ARKANSAS POWER AND LIGHT  
ARKANSAS NUCLEAR ONE - UNIT 1  
CONTROL ROOM DESIGN REVIEW  
FINAL SUMMARY REPORT  
HUMAN ENGINEERING DISCREPANCIES  
VOLUME 2  
AUGUST 14, 1985

Category 1 HEDs

CORRECTIVE ACTIONS

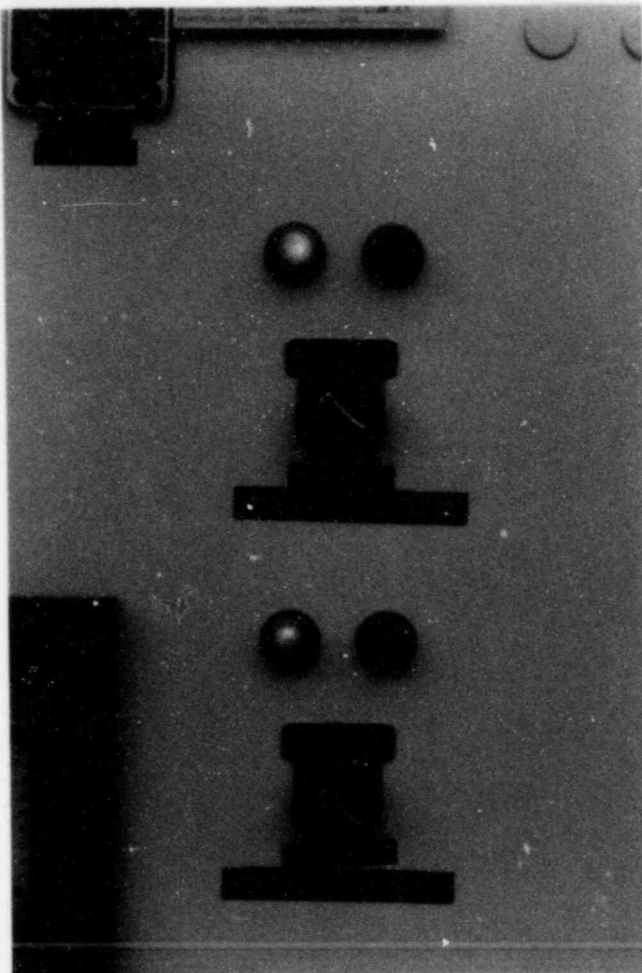
Bottom-to-top alphabetical order of mainsteam to E2A and E2B controls violates top-to-bottom convention.

HED NO.: CK:9-1.001GUIDE NO.: 9.2.3aRATING: 3FINDING:

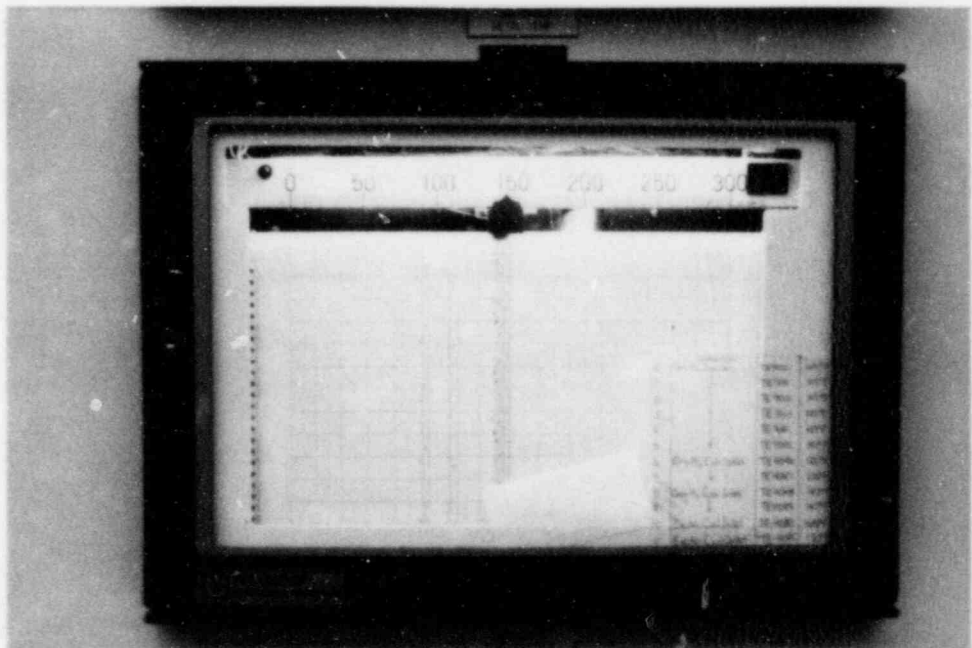
Generator temperatures on recorder TR-9001 not visible from C01 workstation (below front panel edge).

HED NO.: CK:9-1.003GUIDE NO.: 9.2.3.bRATING: 3FINDING:

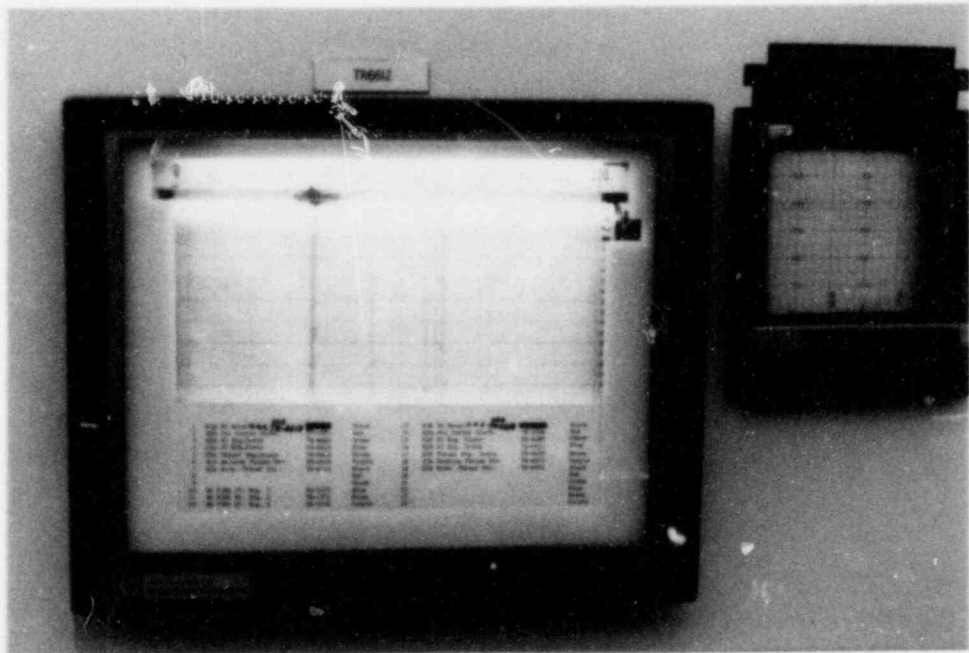
Associated recorder for feedwater pump controls on CO2 is not located in upper vertical panel section. Not visible from CO2 workstation. The recorders affected are Equipment ID# TR6612 and TR6613.

The identified recorders are not required to be visible from panel C-02 since the operation of controls on C-02 do not rely on feedback from these recorders. The recorder TR-6612 is located appropriately for the intended use. The recorder TR-6613 is not used by the plant operators and is to be evaluated for deletion per HED No.: QS:A4.9-1.064. Therefore, due to a lack of justification for change, no further action is planned to address this HED.

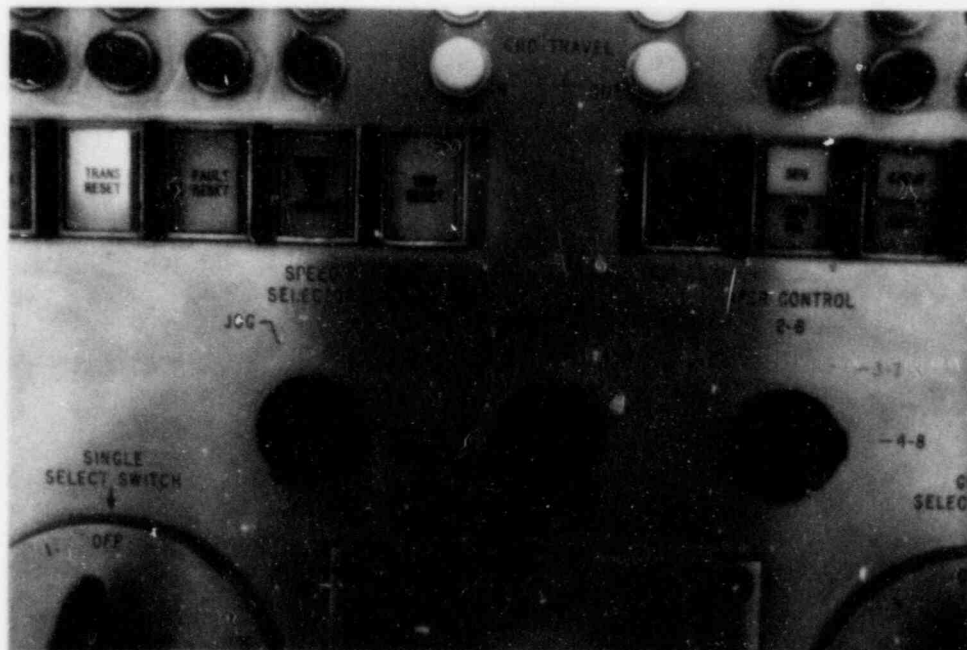
The association of the control rod group selector switch on the rod controller, with the control rod group average indication meters is not readily apparent.

The identified control is not used routinely by the plant operators in conjunction with the group average indication meters. The back panel rod position is the source of rod position information relied upon by the operators which is readily visible and the association is clear through operator training. Therefore, due to a lack of justification for change, no further action is planned to address this HED.

HED NO.: CK:9-1.005GUIDE NO.: 9.2.2.a(1); b(2)RATING: 3FINDING:

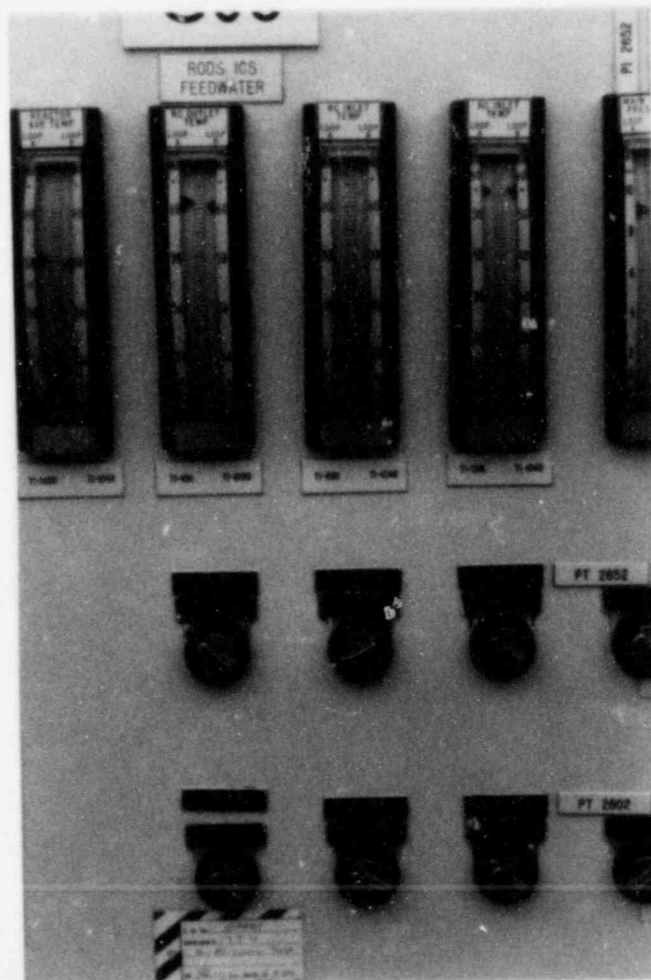
The Loop B meter selectors are not located directly below meters. All the selector switches (A&B) have different label conventions with respect to their associated meter names. Loop A Th; RC outlet Temp; Loop A Tc Narrow: RC Temp. . . etc.. The affected selector switches are Equipment #'s HS1039, HS1044, and HS1045.

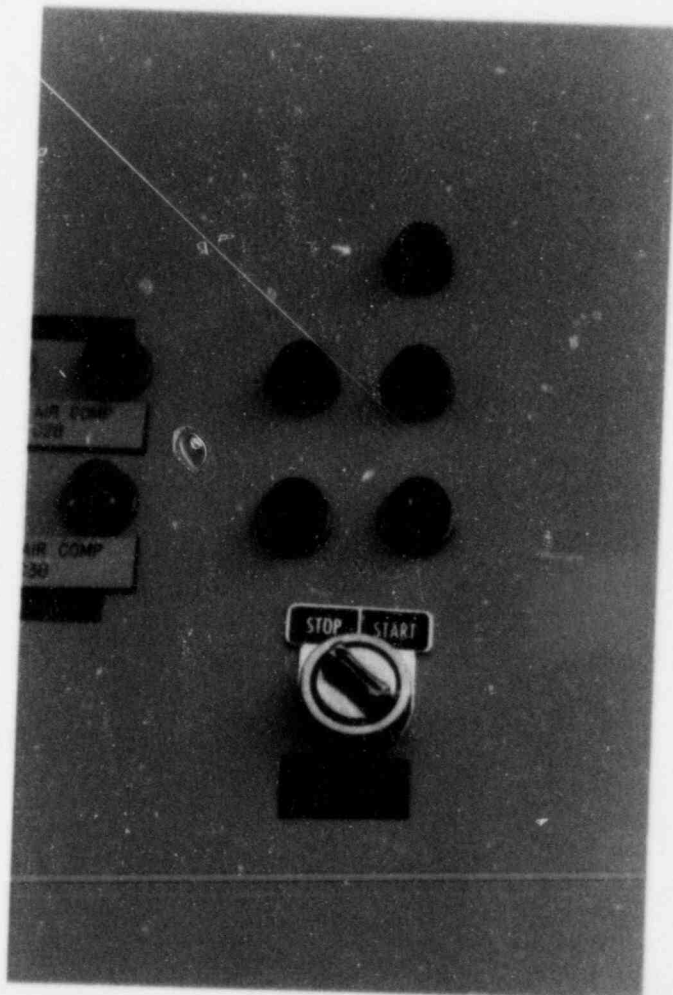
Association and meaning of lights above the 2VSF-9 control is not apparent.

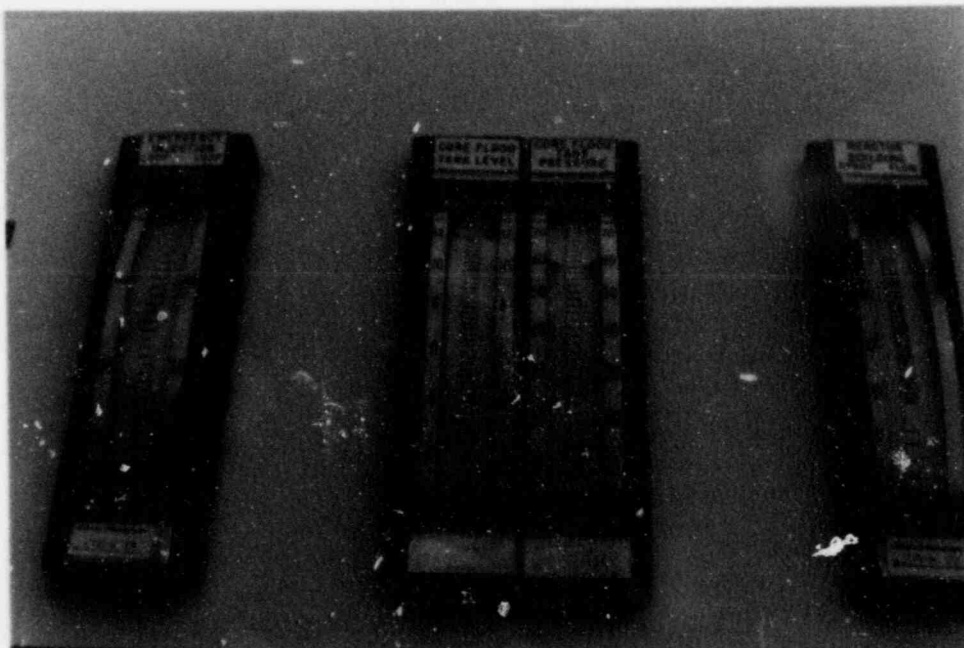
Top row of meters on C-16/C-18, used in control operations, is too high on panel and cause parallax problem.
